## The importance of the Kappi area in the Gunung Leuser National Park and further support for its current *core area* status

The results of a recent report entitled ~ “Harmonization study into renewable energy development in the Gunung Leuser National Park” were presented by a field team from the University of Gadjah Mada (UGM) to the Gunung Leuser National Park Authority on 8th December 2016. The report describes the results of a rapid survey conducted between October 20th and November 6th 2016, aimed at evaluating the “harmonization” required to develop a major geothermal project in the Kappi region of the Gunung Leuser National Park (GLNP). This area has correctly maintained a status of *core area* (‘zona inti’), due to it meeting or exceeding all legal criteria highlighted below, namely its unique geological formations and exceptionally rich biodiversity, which includes the presence of all four of Sumatra’s most iconic Critically Endangered species, Sumatran elephants, orangutans, rhinos, and tigers.

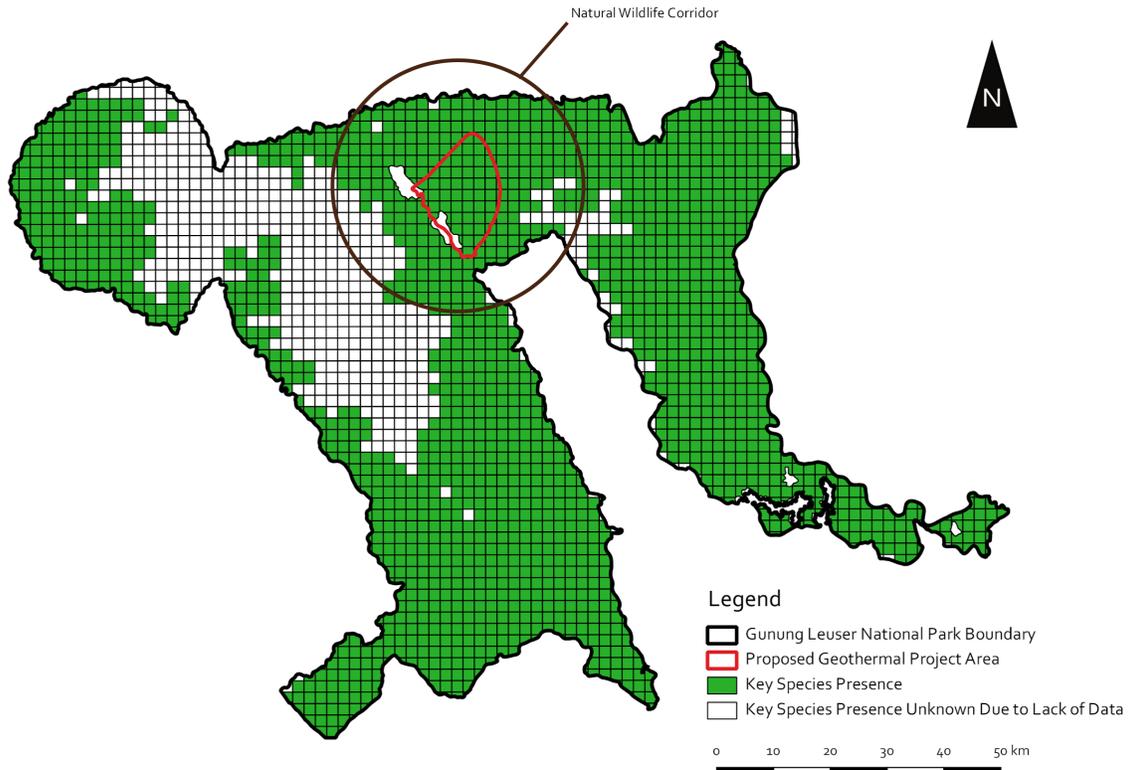
The underlying recommendation from UGM’s short report suggests that there is potential for the development of a large geothermal project, as is proposed by PT Hitay Panas Energy in the area delineated in Figure 1. In particular, one section of the UGM report focuses on a legal appraisal of the proposed new plant stating that under the current situation, the project would be

illegal since the proposed site lies in the *core area* of the national park in which no such development is permitted under national law. Despite the clear and vital importance of the Kappi area to the integrity of the GLNP and all its biodiversity, the UGM team have suggested that if the *core area* status of the affected area was changed to *utilization area* ('zona pemanfaatan'), there would be no other legal obstacle preventing project development.

1. The report submitted by UGM suggests that the operational and exploration zones for the proposed geothermal plant are roughly 500 and 5,000 ha, respectively. However, it is unclear from the study how and why the study area was chosen and/or demarcated. The only comment is that it is "representative" of the area of GLNP that requires "harmonization", due to potential "management conflicts". Thus, from a reviewer standpoint, it is impossible to know how representative the study area is with regard to the actual proposed geothermal project site. One additional glaring omission of the study area is that it does not incorporate any survey locations between Jl. Raya Blangkejeren-Kutacane and the proposed project areas despite the fact that the development of a geothermal project will require major access roads and the impacts of these areas must also be assessed;

Given the facts detailed above and that the Kappi area of the GLNP is already designated as *core area* status, we recommend that the status of the Kappi area remains as such. We also highlight that the currently available data from the GLNP Authority and local NGO affiliates more than adequately supports rejection of the proposed zonation change necessary to enable the development to go ahead legally.
